**Case File Number: PLN 19070**

**April 24, 2019**

# CITY OF OAKLAND PLANNING COMMISSION

Case File: ZPI80118  
Applicant: K to College DBA Supply Bank Org.  
Address: 0 Oakport St  
Zone: D-CO-6

SHEET  
**A4.1-3**

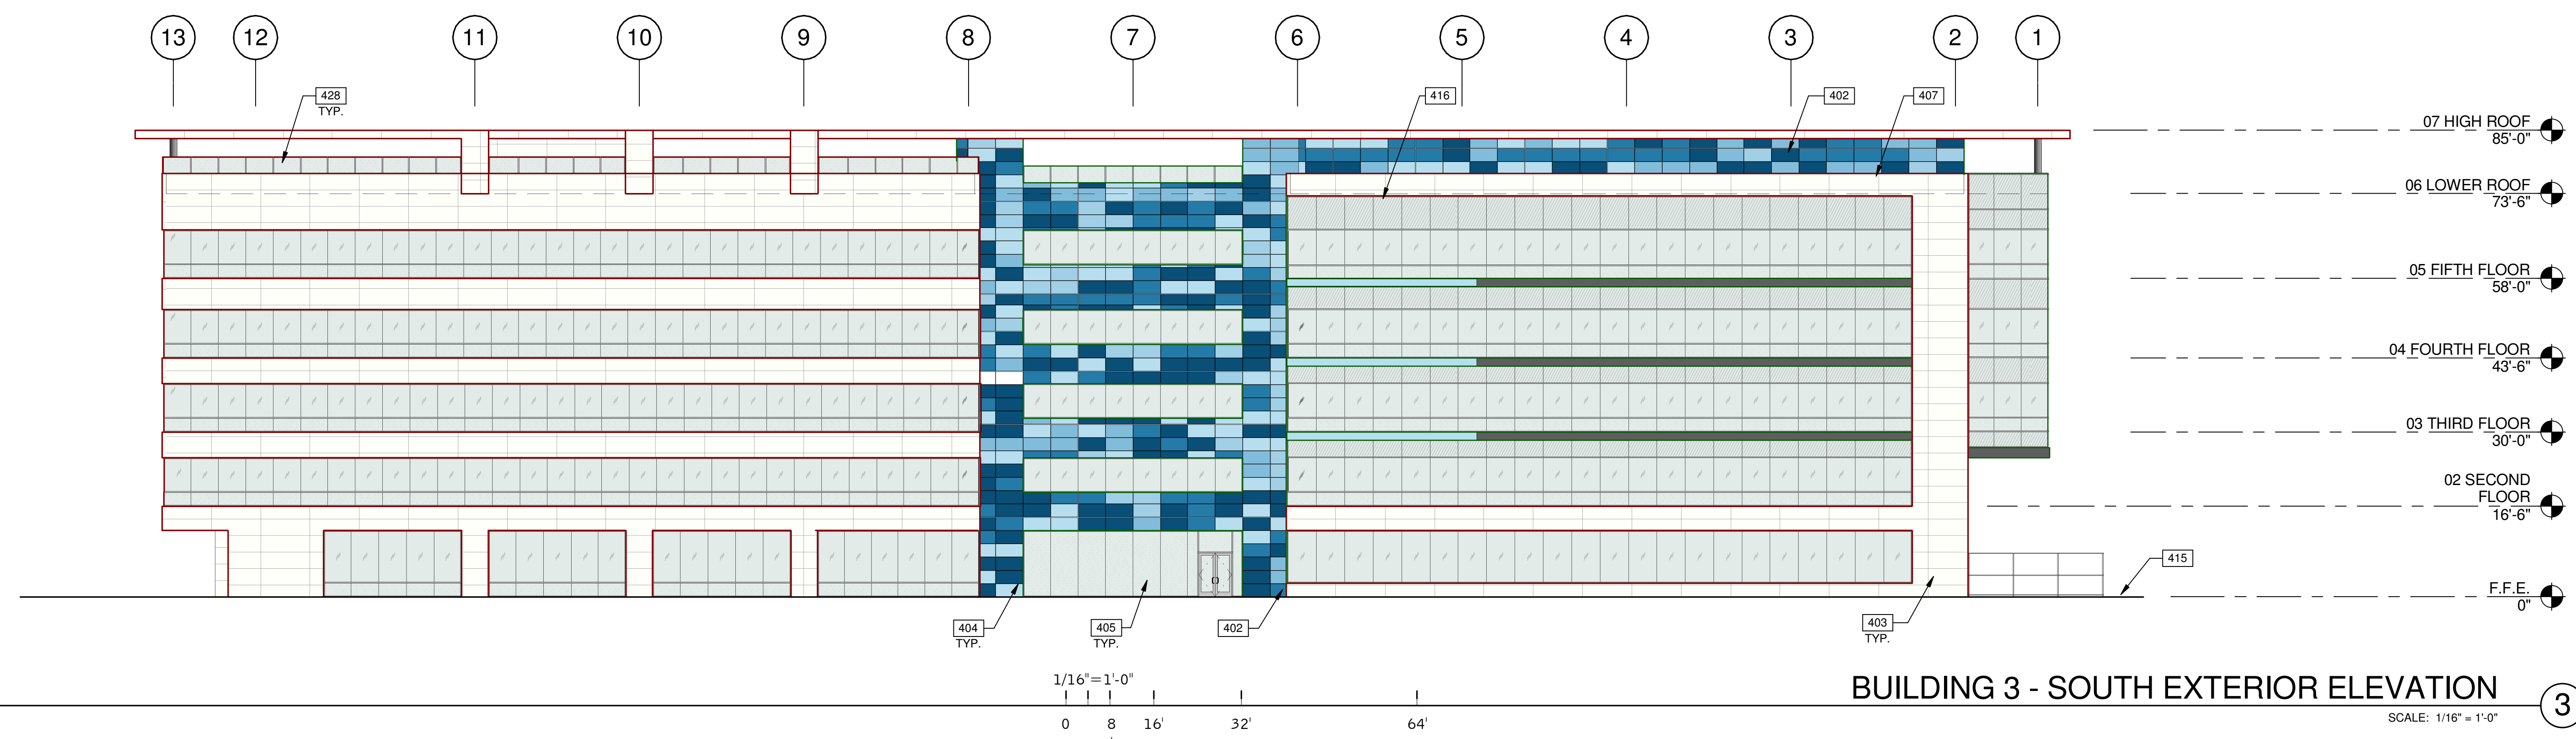
### **3. Office Building Plan (See Sheet A4.1-3A4.2-3)**

The front elevation base building and lobby elements need further clarification. The front lobby element extends beyond the building wall on the first floor. On the second floor, there is a patio above this first floor projection. This portion of the building is shown in the perspective drawings on page AO.1 and AO.1b. and on the building first and second floor plan on pages A2.1-3 and A2.1-3. It is not clear why this element is needed and what it adds to the overall design. The front entry area is already defined by a) first two floors of the building that are recessed on either side of the core and b) the columns which terminate at the ground on one side of the entry, and end in a horizontal band above the entry. A tile wall is shown in perspective and elevation at approximate size of the entry storefront window system. These elements would adequately define the entry of the building. The addition of the projecting lobby element detracts from the appearance of the front façade and seems inappropriate for an office building.

1. Office Building Lobby: Staff requests that DRC provide direction on this design element. Staff recommends modification to both the size and shape of this entry feature.

SHEET  
**A4.1-5**

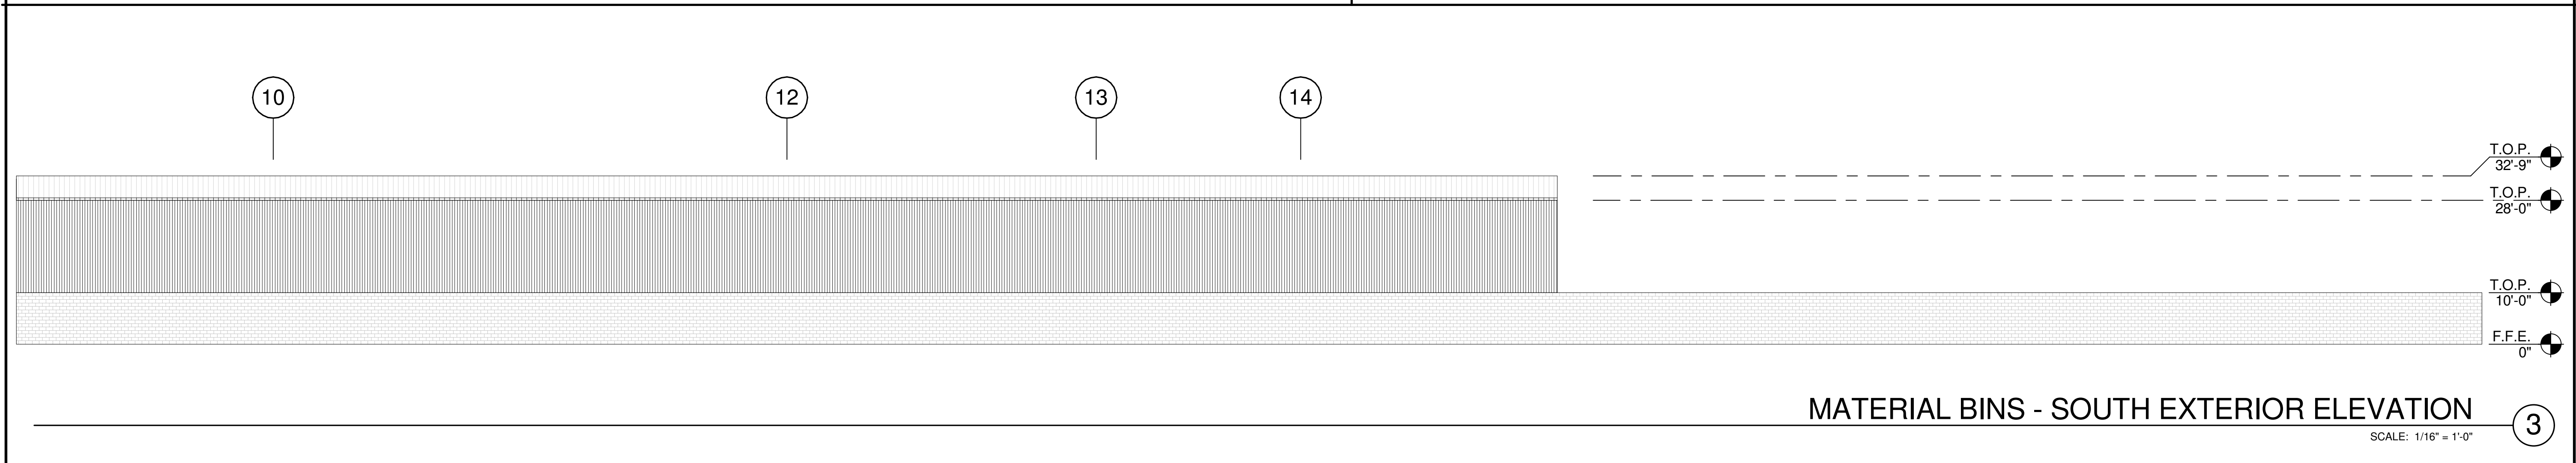
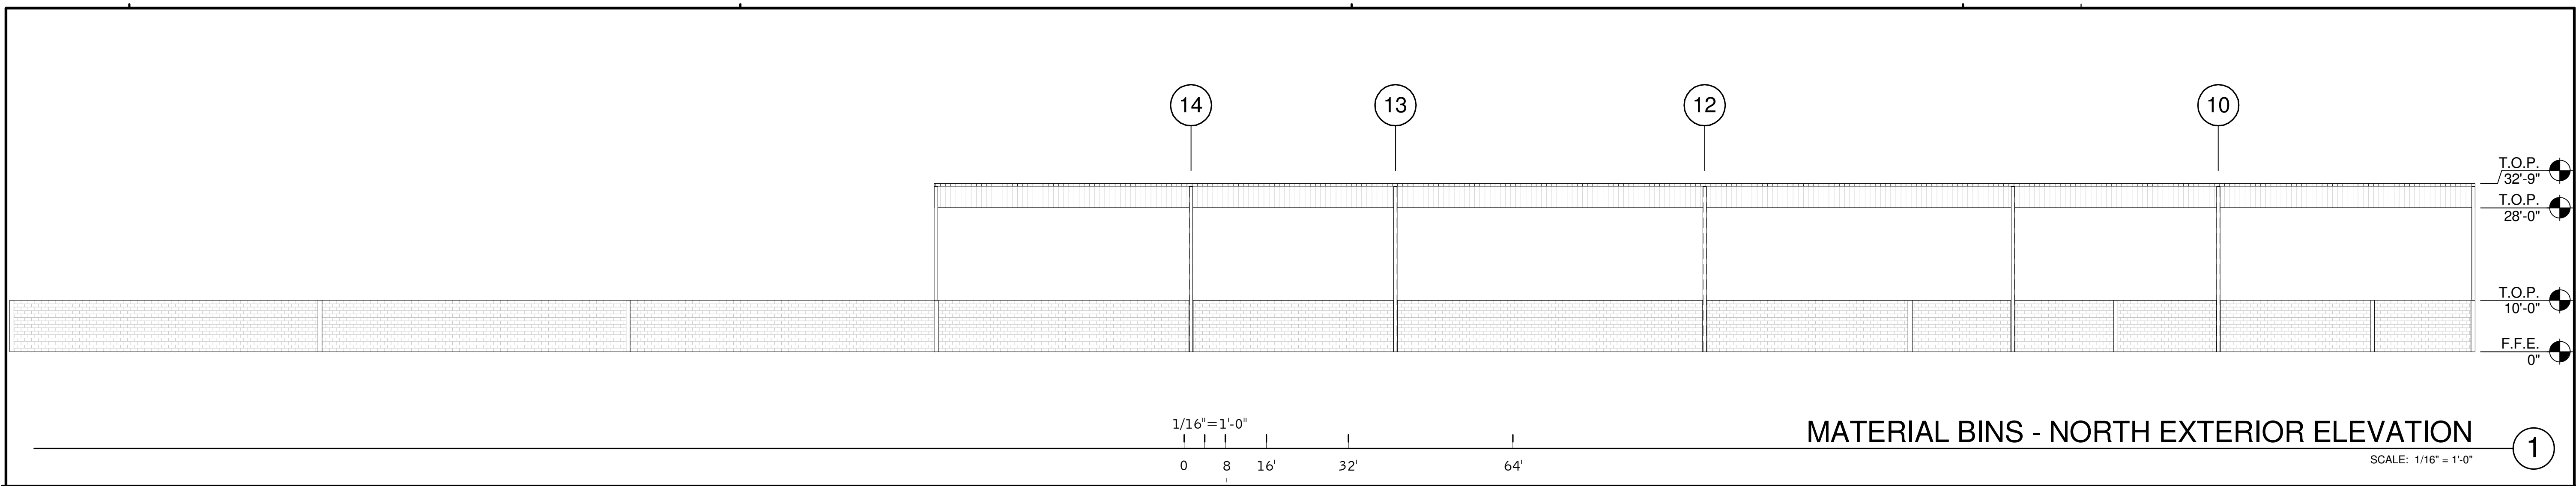
### Other Accessory Structures (See Plan sheets A2.1-4 A4.1-5 and A4.2-5)

The plan includes covered materials and scrap bins and a covered pipe laydown area in the EBMUD corporation yard. These accessory buildings are pre-engineered structures with concrete wall and simple rooflines. The pipe laydown shed is 36' high at the highest point of the roof with a 28' wall height. The materials bins shed has a shed roof that is 32' at the highest point. Both sheds will be painted in gray tones using the color palate proposed for the other buildings. The plan also shows a walkway connecting the back of the office building to the warehouse. The walkway is design with a simple roof and metal pillars.

SHEET  
**A6.2**

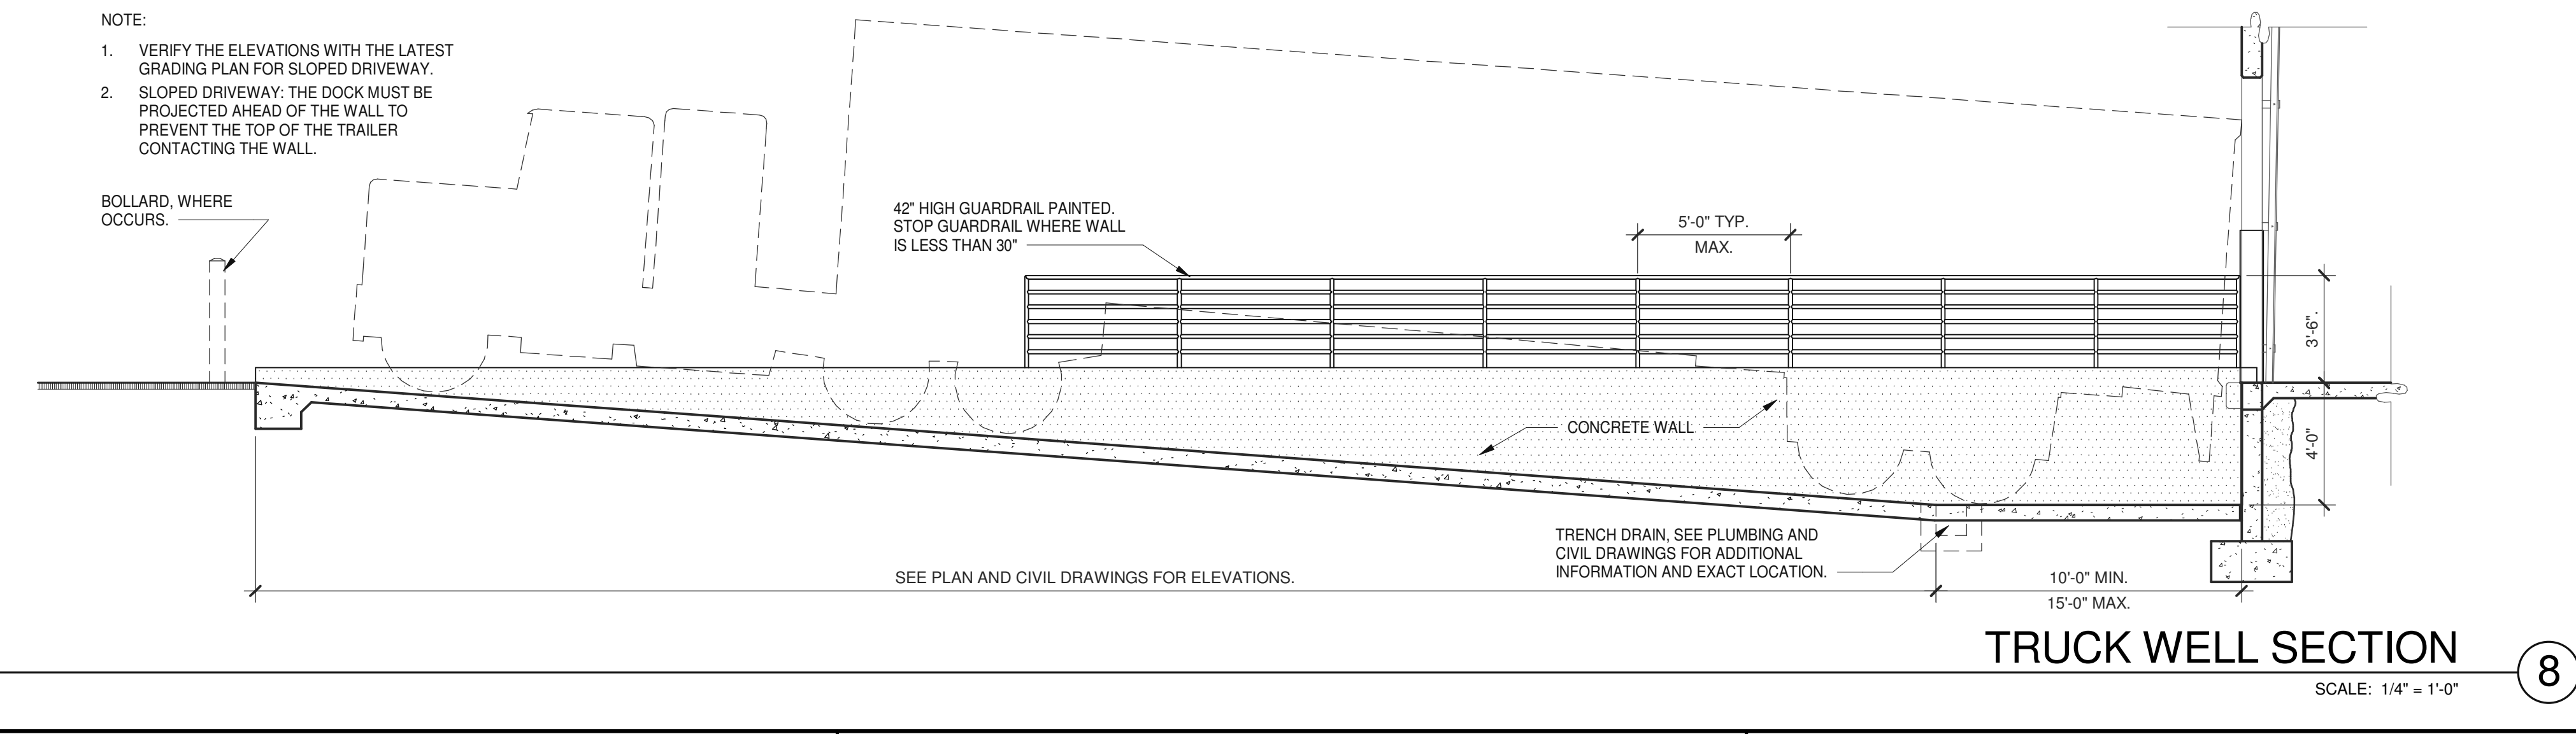
9. Fence Height	8 feet adjacent to Open Space Zones	3-4' retaining wall 8' fence around the property perimeter. Site plan and detail sheet Plan set p. A6.2 S show both "chain link" and "wrought iron" fence Applicant to clarify location of each on site plan.	Complies but design review issue
